Subject: FW: Cockpit Farm revised landscape details - DC/26/101166

Subject: Re: Cockpit Farm revised landscape details - DC/26/101166

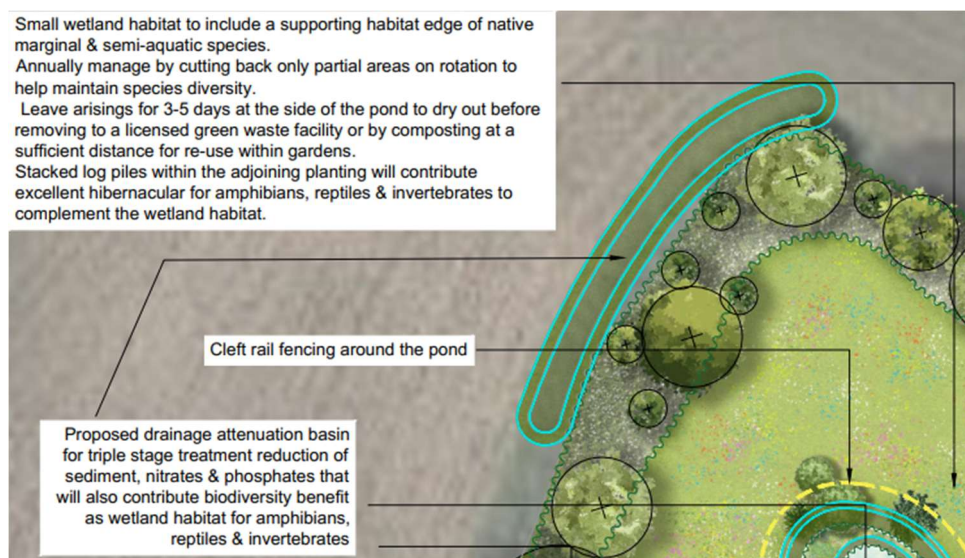
9/ The strategy plan notes a small wetland habitat adjacent the central basin:

I cannot see this wetland habitat on the detailed planting plan? At present the area is specified as EM3 mix whereas a wetland/marginal mix would be more appropriate.
